## Flex Pipe, Diesel Particulate Filter (DPF) Inlet VN

### SP 252-030, Flex Pipe, Diesel Particulate Filter (DPF) Inlet

(February 2014)

W2087509

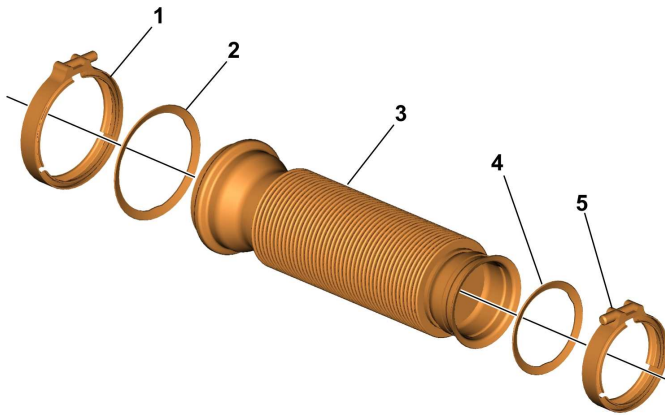
Volvo Trucks has established that the fiber layer found in the flex pipe between the DPF and the engine turbocharger with Cummins ISX engines can deteriorate under certain conditions and may be drawn into the exhaust stream leading to a plugged DPF. A new flex pipe design has been released to address this issue and to increase the durability of the flex pipe. This campaign only covers the replacement of the flex pipe for vehicles built between April 1, 2013 and January 10, 2014.

**Note:** Flex pipe **MUST** be installed as straight and parallel to the engine turbocharger outlet pipe and DPF inlet pipe as possible. Flex pipe should NOT be installed in a curved manner.

**Note:** DO NOT, pry on, excessively bend, flex or twist the flex pipe to install. Failure to follow these guidelines may lead to premature failure of the flex pipe.

- 7 Remove flex pipe, gaskets and V-band clamps.
- 8 Clean all gasket sealing surfaces.
- 9 Loosely install the new gaskets, flex pipe and V-band clamps. Align flex pipe before tightening clamps.

**Note:** Loosen the engine turbocharger outlet pipe and adjust as needed to achieve correct alignment of the new pipe.

- 10 Tighten V-band clamps to  $8 \pm 2$  Nm ( $70 \pm 18$  in-lb).
- 11 Start engine. Check for exhaust leaks.
- 12 Install the right side splash shield/inner fender.
- 13 Install the right chassis side fairing if removed.
- 14 Close and latch the hood.
